Contract #: 04-0120F4Cty: SF/ALA Rte: 80 PM: 13.2/13.9File #: 69.25B**QUALITY ASSURANCE -- NON-CONFORMANCE REPORT****Location:** Changxing Island, Shanghai, PRC**Report No:** NCR-000152**Prime Contractor:** American Bridge/Fluor Enterprises, a JV**Date:** 23-Jun-2008**Submitting Contractor:** Zhenhua Port Machinery Company, Ltd (ZPMC), Changxing Island**NCR #:** ZPMC-0143**Type of problem:**

**Job Name:** SAS Superstructure

**Subject:** NCR No. ZPMC-0143

Scheme showing the test part

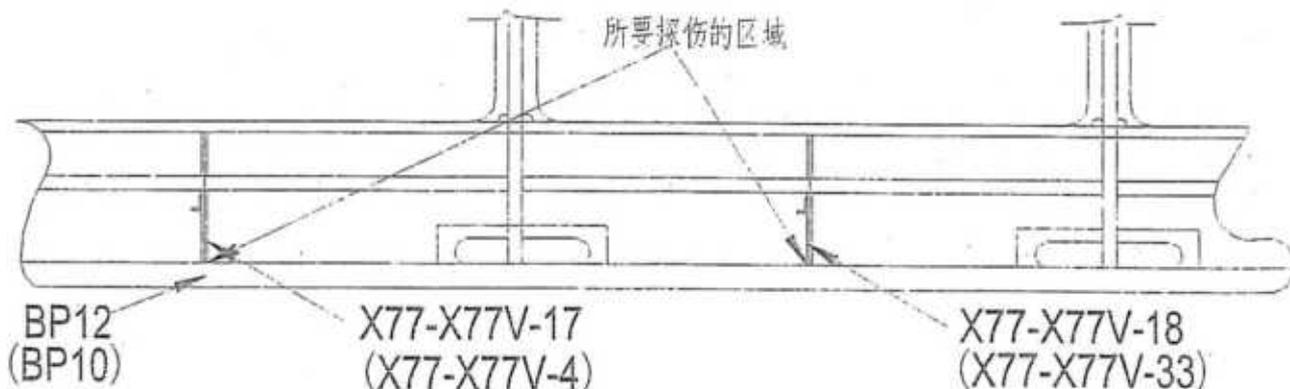
With this letter of response, ZPMC requests closure for Caltrans NCR-000152(ZPMC-0143). According the comments from the caltrans that "please provide magnetic particle testing documentation of the area of weld removal", we provide the corresponding MT report to prove the good quality for the 'tight fit' areas. Therefore we think the department can review the proposal again.
